### ADDENDUM 1

## Austin Elementary School Heating & Air Condition (HVAC) Improvements Funded through the Elementary & Secondary Emergency Relief (ESSER) Funds May 31, 2022

## Addendum

**PROJECT** 218007.004 | Edinburg CISD - Stephen F. Austin ES - HVAC Improvements

**3 A/C CLOSET - LOUVER INTAKE - ADMINISTRATION UNITS**  
 M3.02 1/2" = 1'-0"

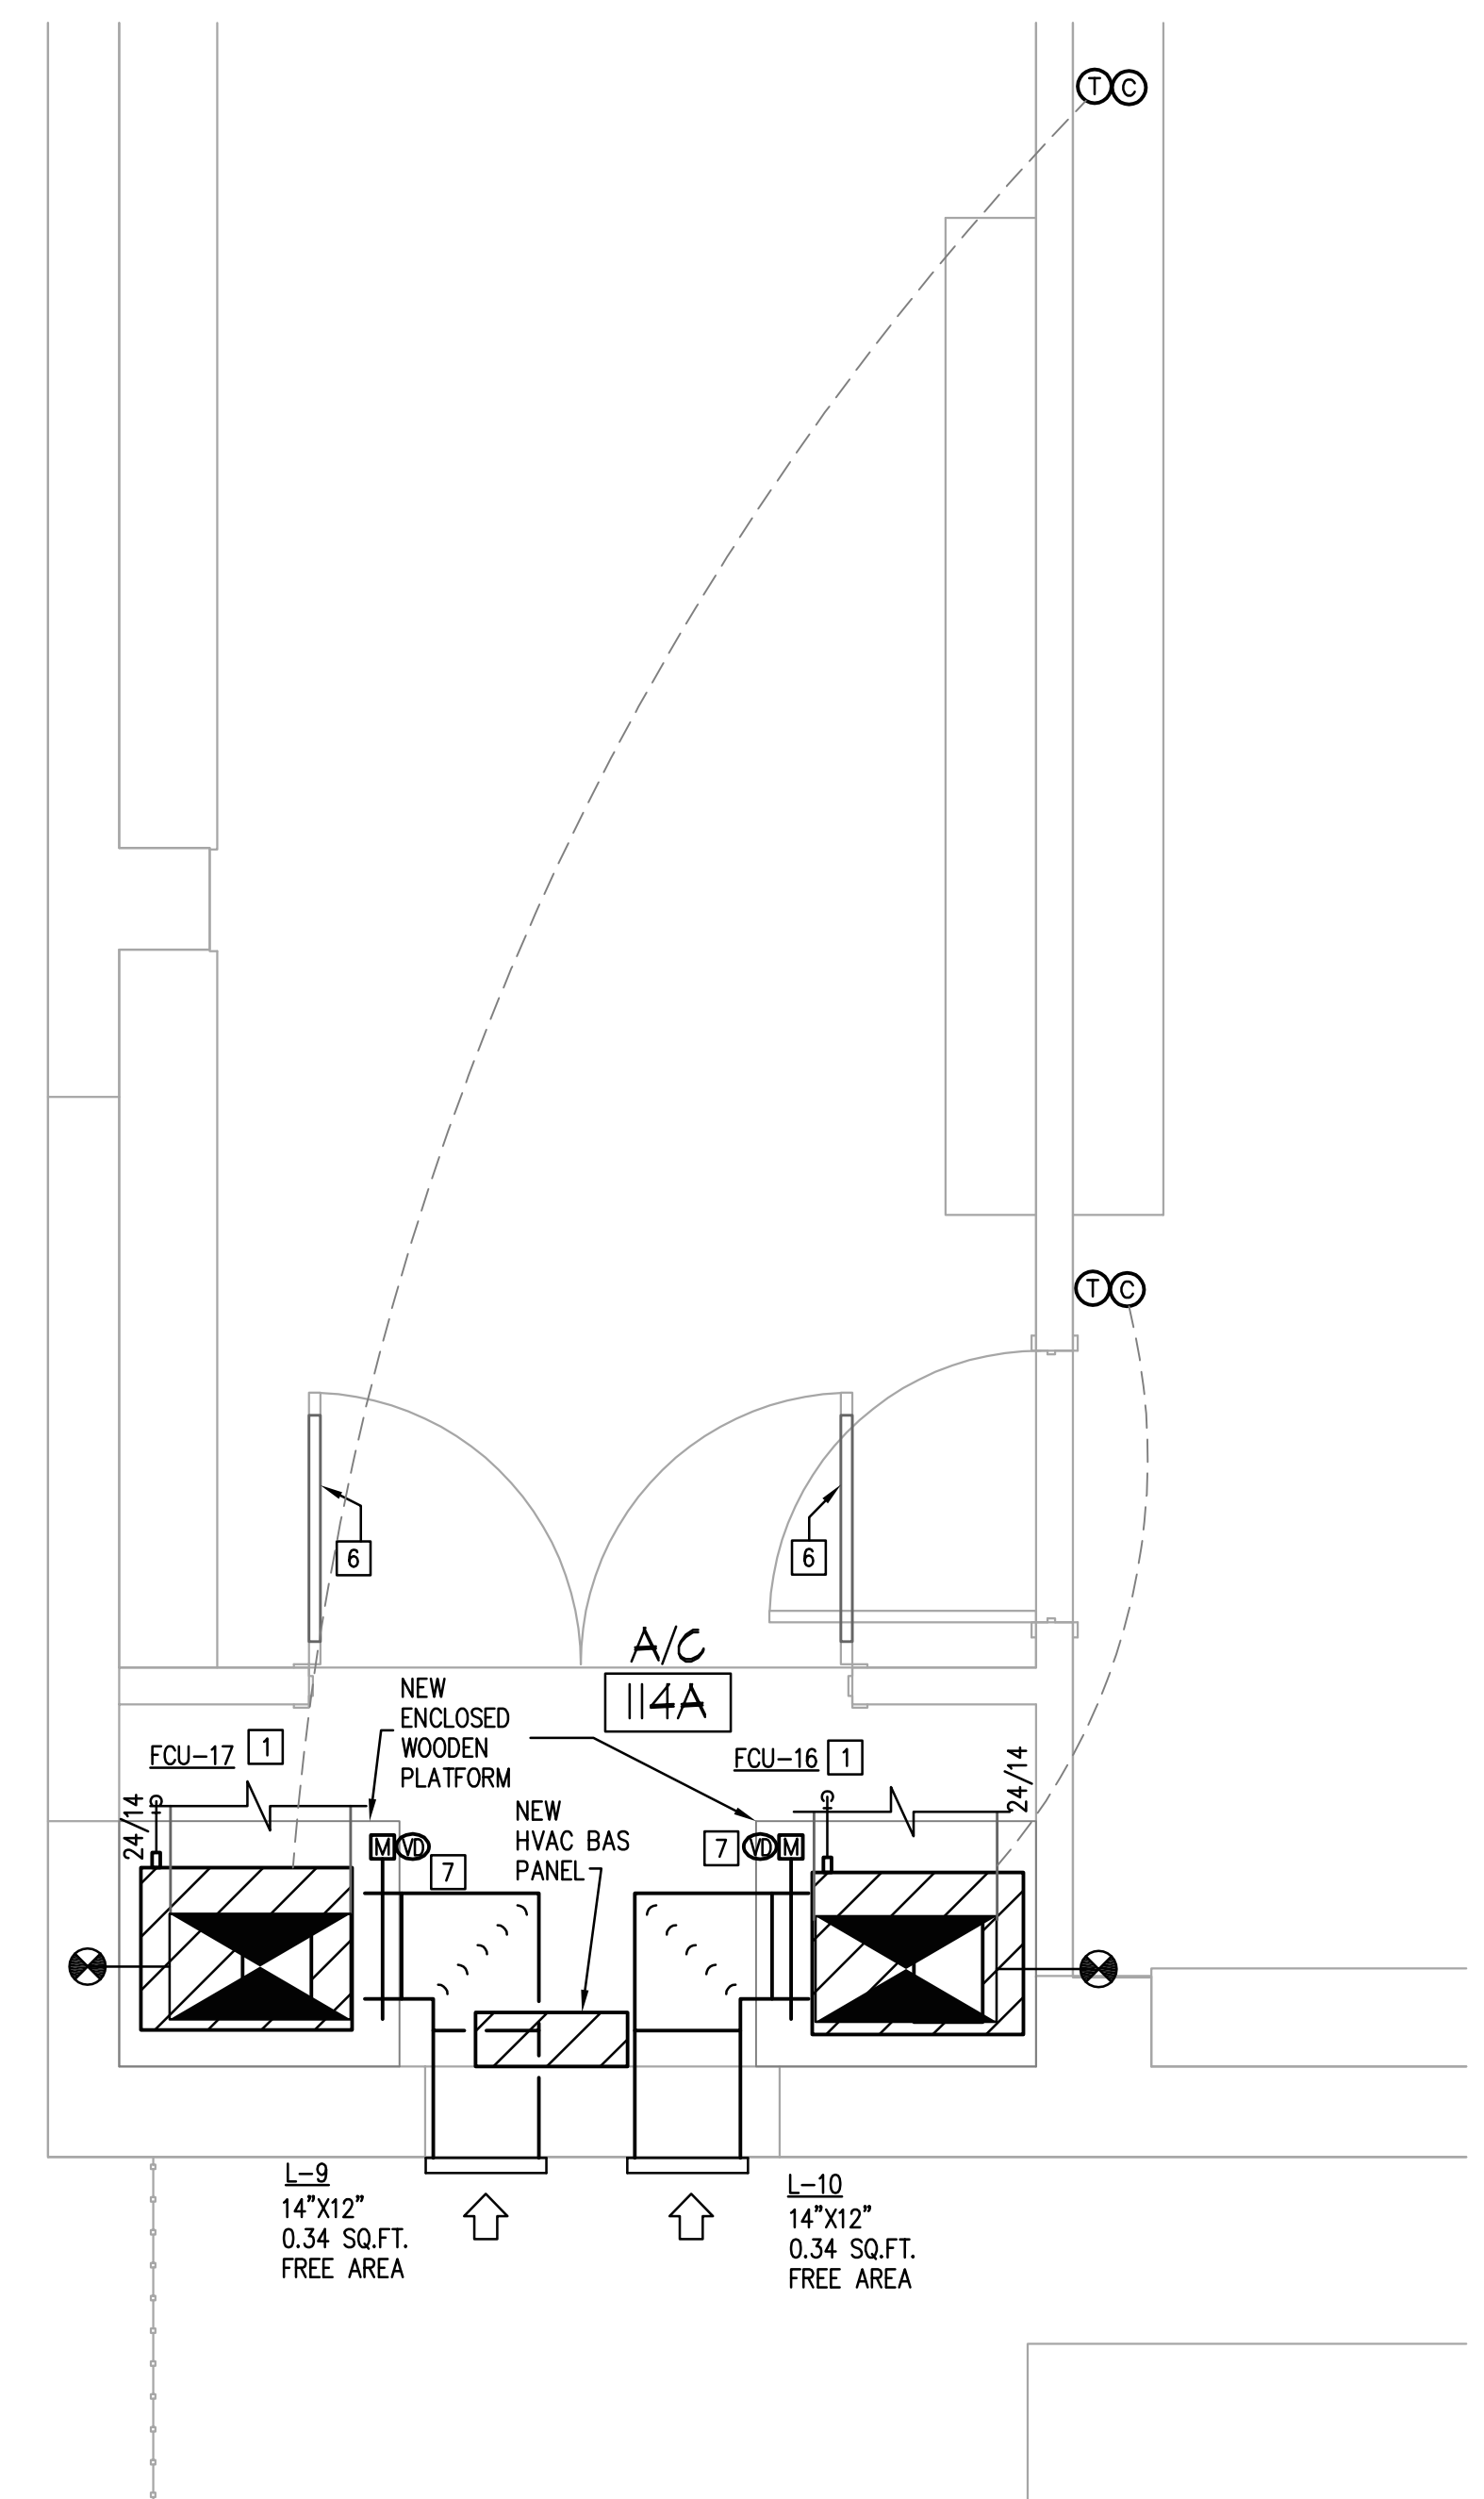
**Item 10 M3.02 – Enlarged Mechanical Plan**

- A. Revised keyed notes 2, 7, 9, 11, 12.
- B. Revised Louver L-8 size.
- C. Indicate outside air routing to each fan coil unit in Mech. Rm in 3/M3.02.

DATE:	05/05/2022
DRAWN BY:	DBR
CHECKED BY:	DBR
PROJECT NUMBER:	218007.004
SHEET TITLE:	LEVEL 1 ELECTRICAL POWER PLAN - DEMOLITION
SHEET NUMBER:	EPD2.11

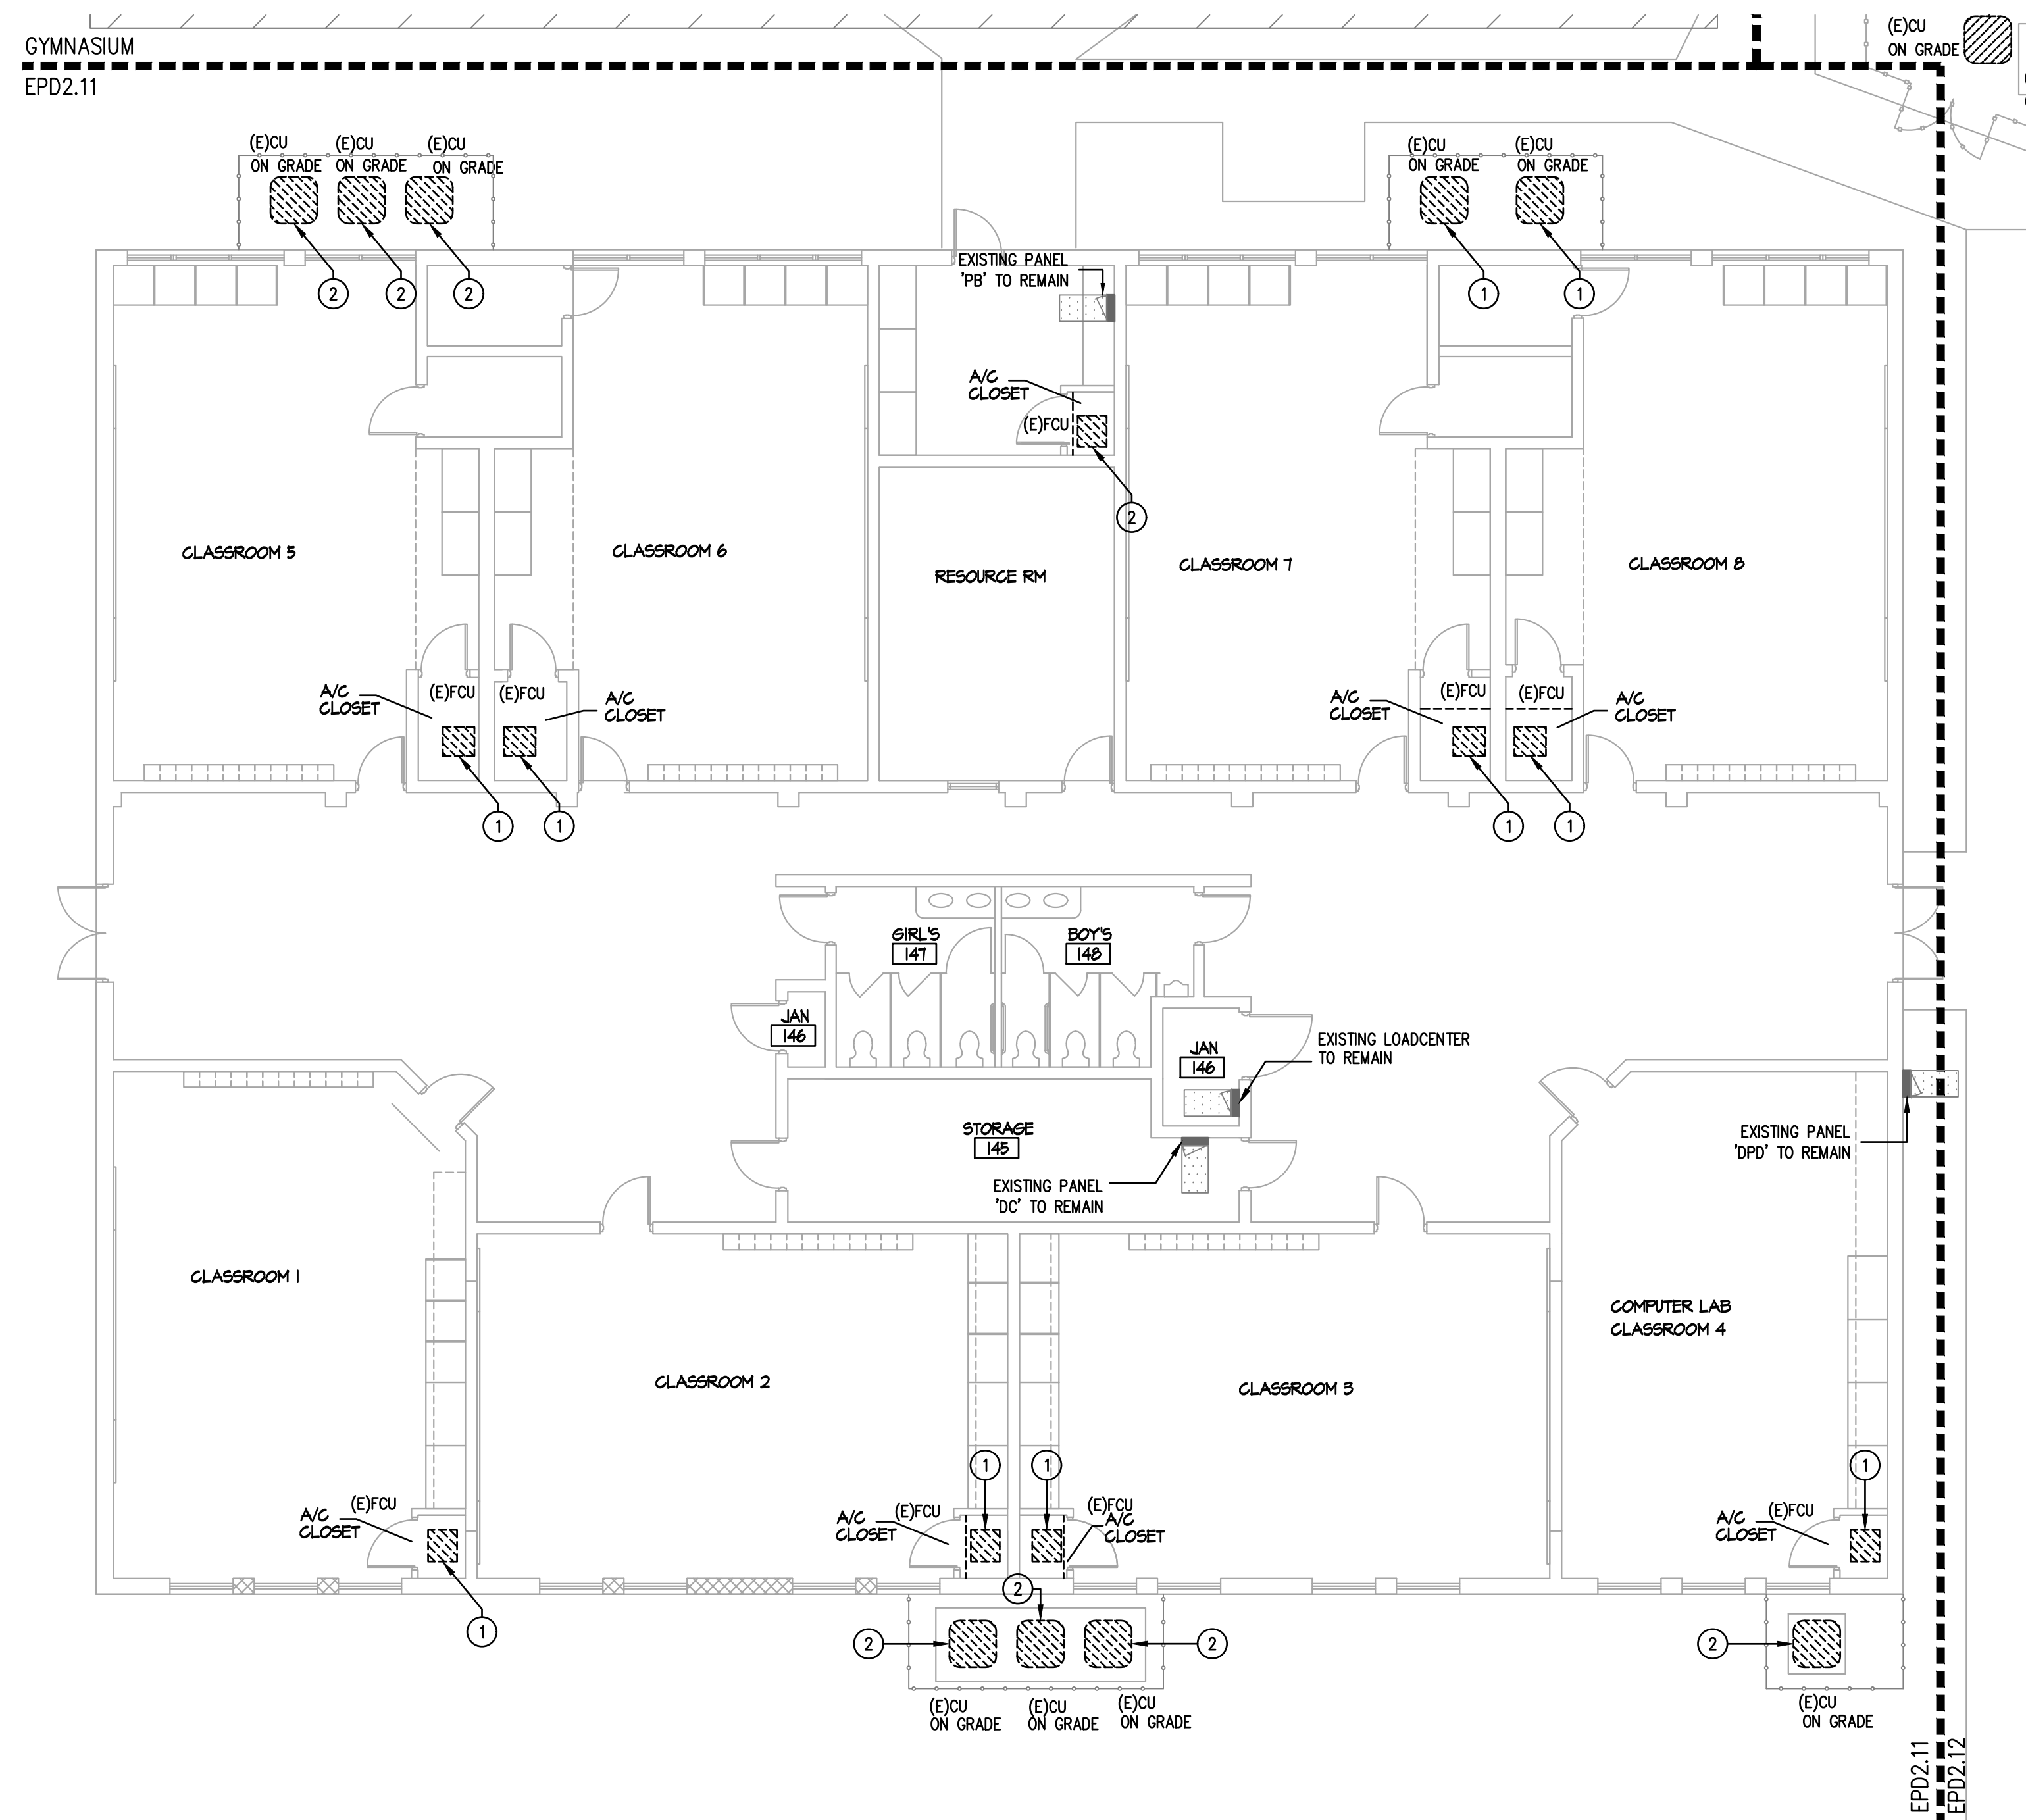
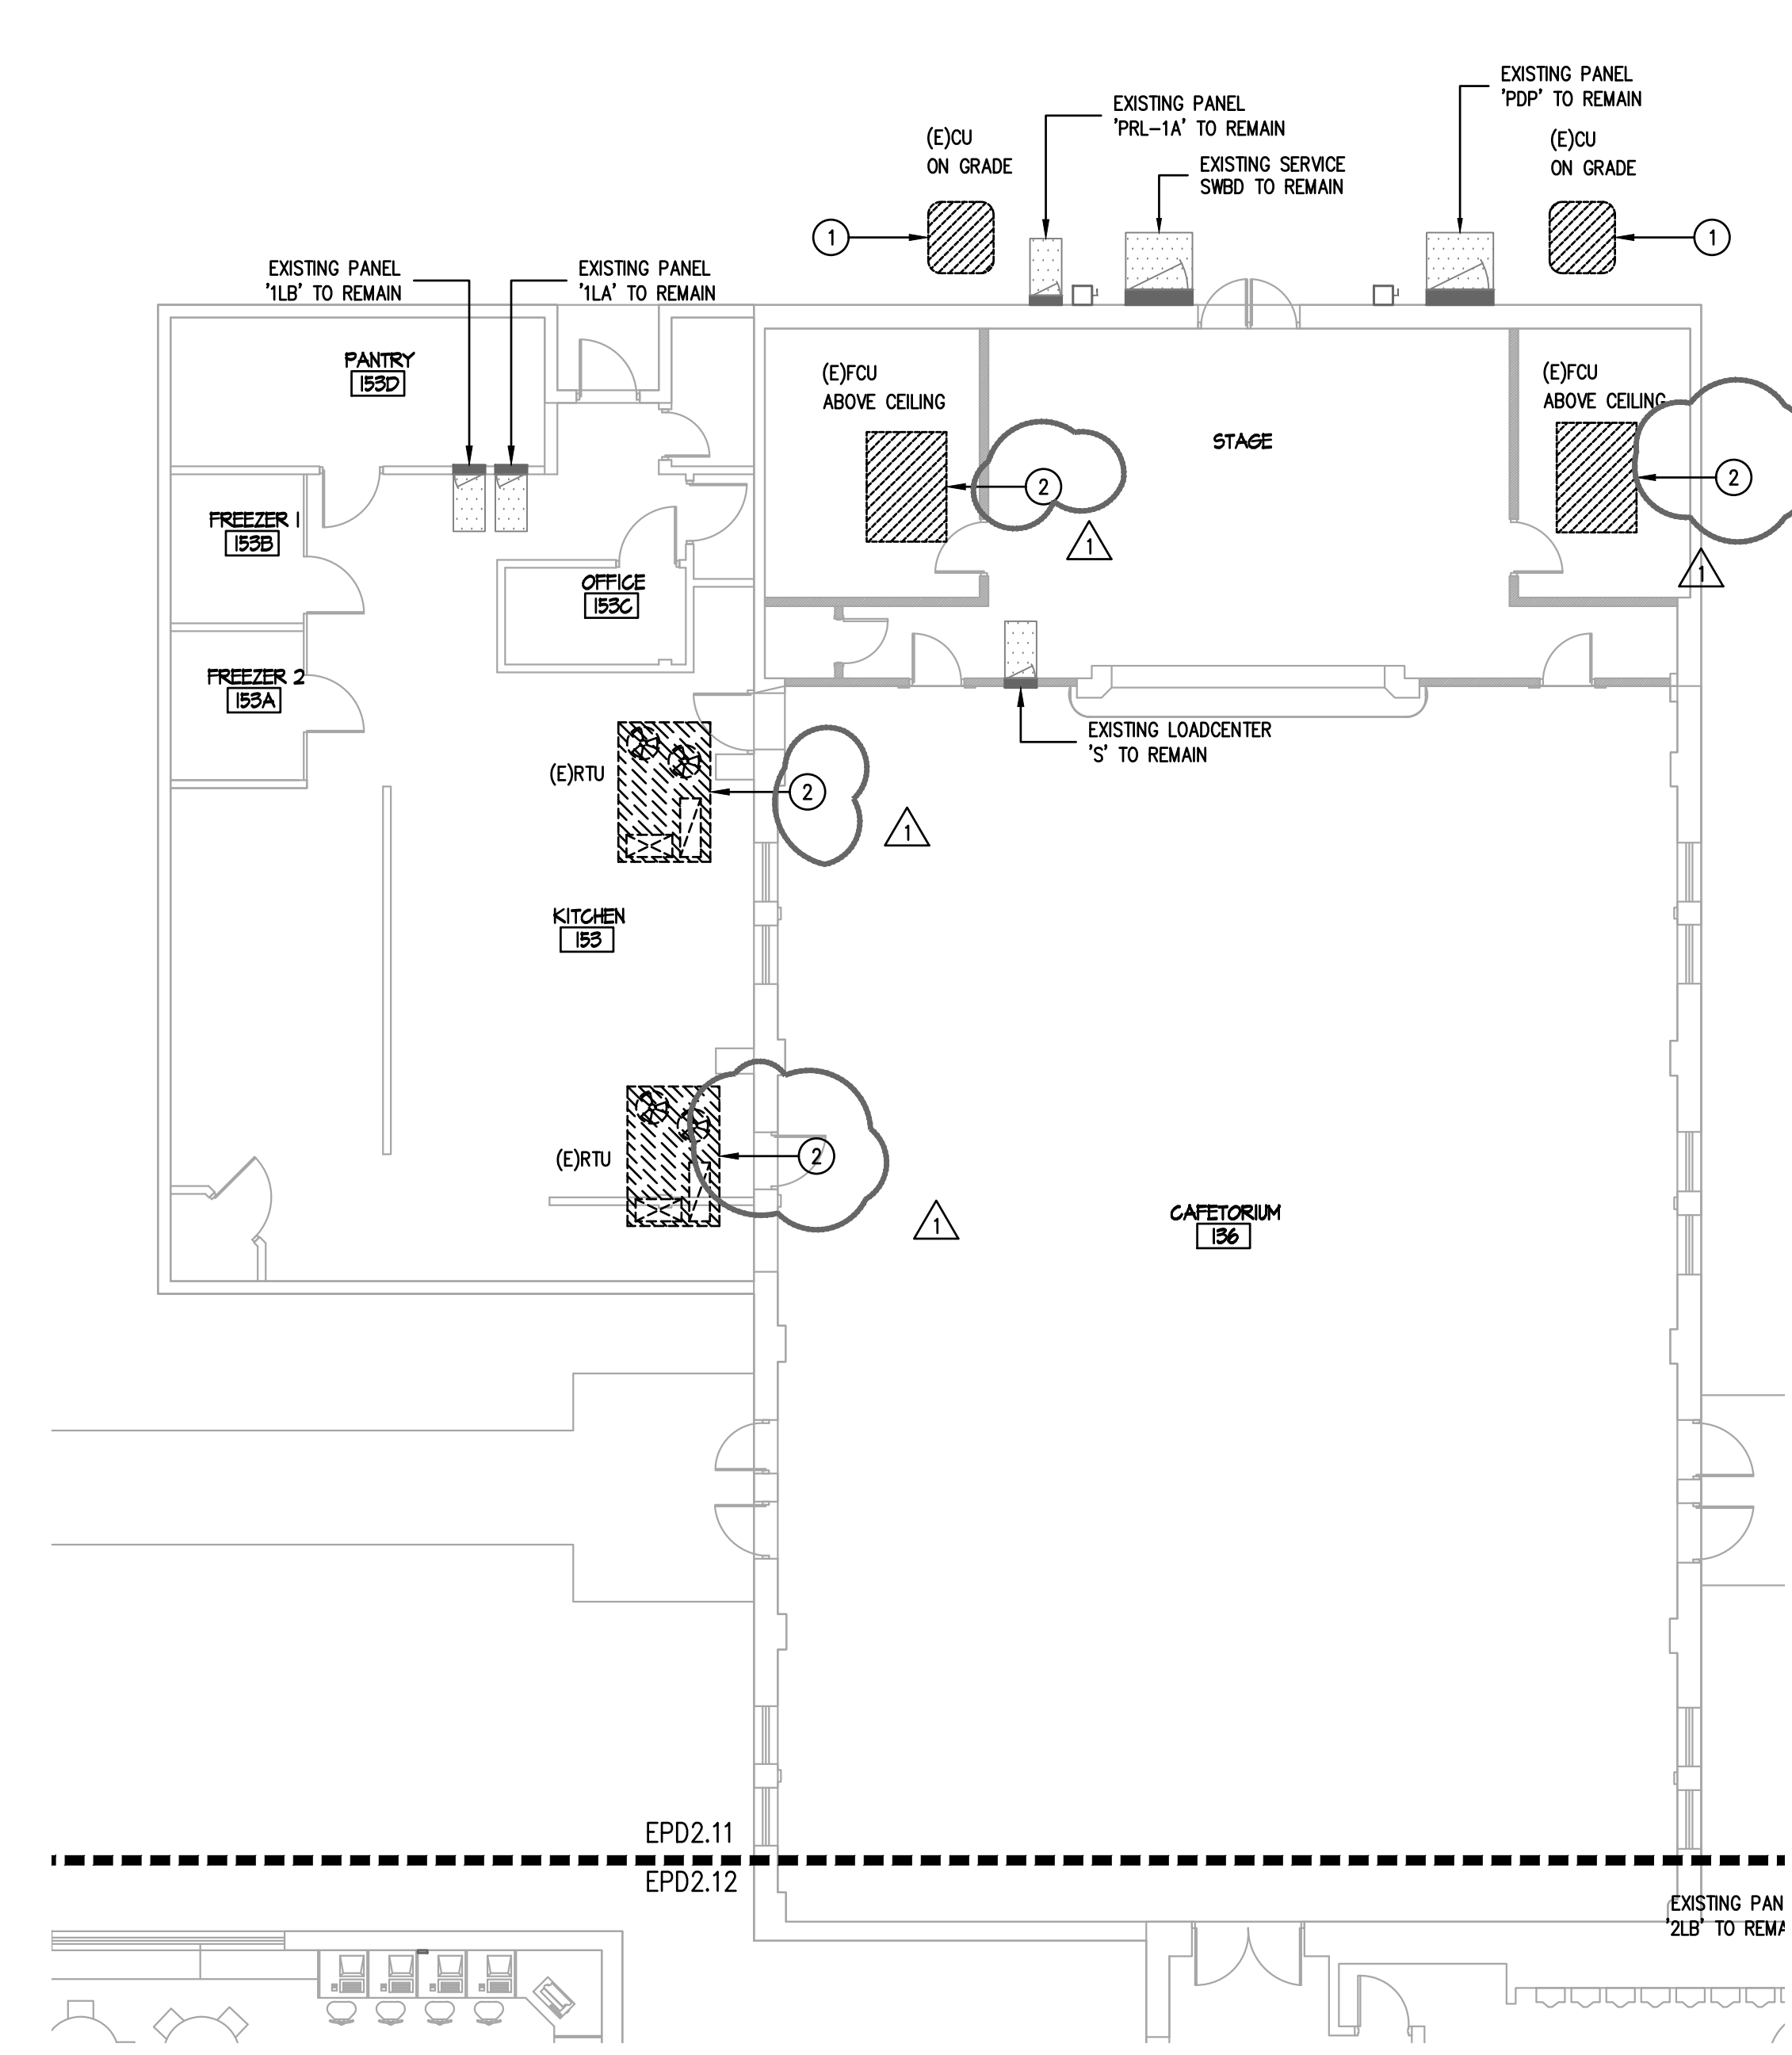
**Item 14 EPD2.11 – LEVEL 1 ELECTRICAL POWER PLAN – DEMOLITION**

- A. Revised keyed notes.
- B. Revised noted equipment.
